Mt. Pleasant Fire Department

Occupancy: **WALMART**
Occupancy ID: **50A**
Address: **2311 JEFFERSON Mt. Pleasant TX 75455**

Form: MPFD Inspection Form - NEW

Inspection Type: **Reinspection**
Inspection Date: **1/9/2026** By: Evans, Charles
Time In: **14:56** Time Out: **21:00**
Authorized Date: **01/09/2026** By: Evans, Charles

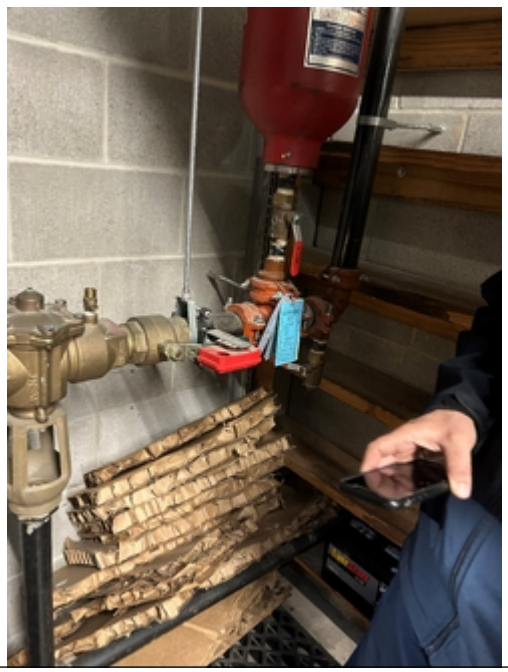
Status: PASS
Notes: All ceiling tiles that are missing throughout the store need to be replaced.

Corrected

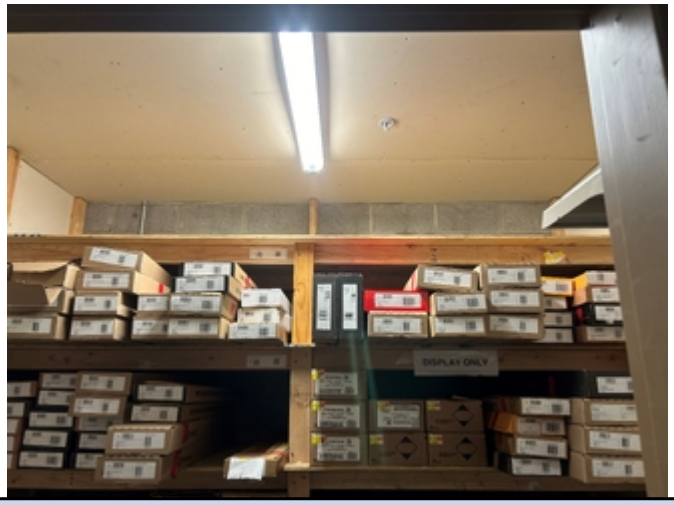
Status: PASS
Notes: There is no way for the water to access the lower parts of the storage rack if something were to catch on fire. I would recommend wall mounted sprinkler heads or having a wire style storage racks.
Also there needs to be an (explosive) placard on the door of the room where the guns and ammo is stored.

Re visited on 12/3/2024. Still not taken care of.

Corrected as of 1-9-2026 The Sprinkler head has been relocated to point towards the wooden rack.
Note: Advised store manager to place a sign on the door entering the ammunition area stating "Live Ammunition"

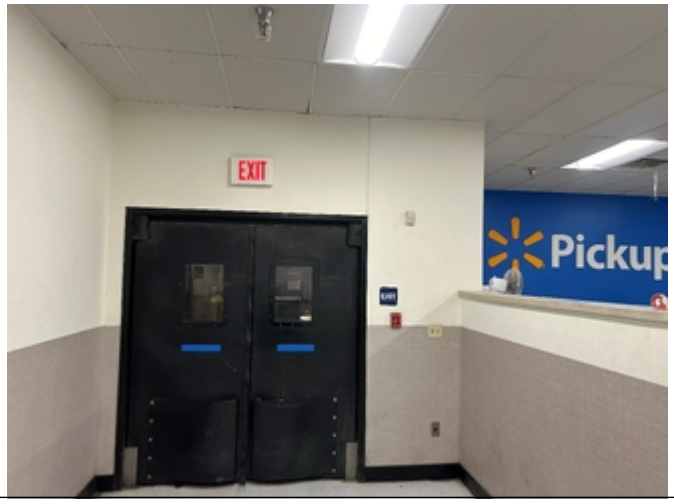
Status: PASS
Notes: These doors are located in the photo lab. We ask that there is a "roof access " sign mounted here and on the fence that goes to the roof access ladder. Preferably a 12x12 sign with 2 inch letters.

Corrected as 1-9-2026
